PERMIT

A REPAIR

ON-SITE SEWAGE DISPOSAL SYSTEM HOWARD COUNTY HEALTH DEPARTMENT BUREAU OF ENVIRONMENTAL HEALTH

SUBDIVISION: Sand Hill Acres LOT NUMBER: 1-C

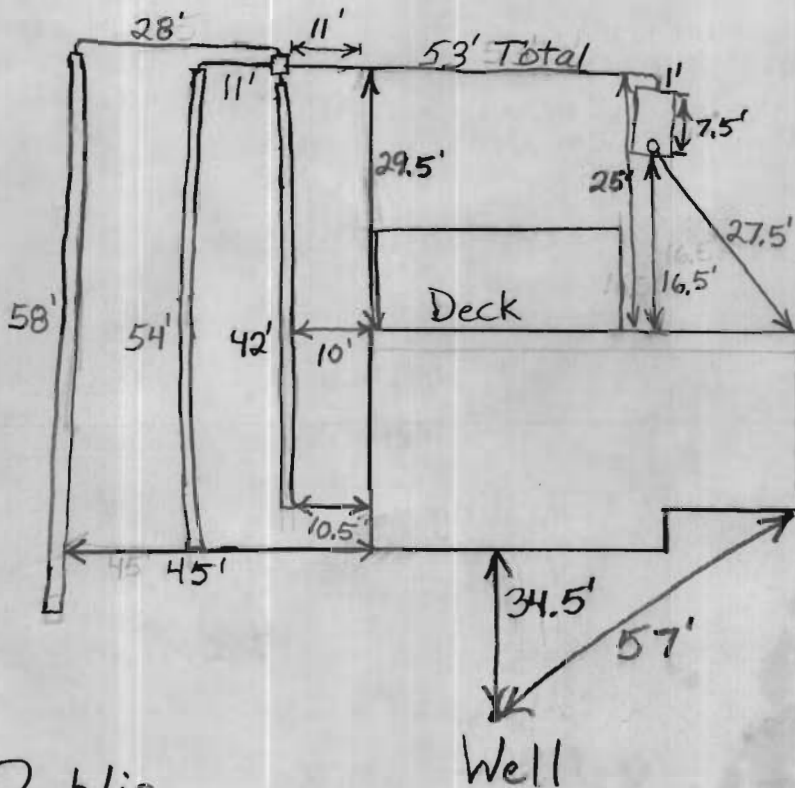
PRE-CONSTRUCTION 9/22/05 To install 3 trenches on the right side of the house. O.K. if less than 20' from house.

INSTALLATION Pump out and fill in the drywell. (BB) 9/23/05 Drywell filled in per contractor. Contractor 20' short with total trench length. O.K. to backfill. (BB)
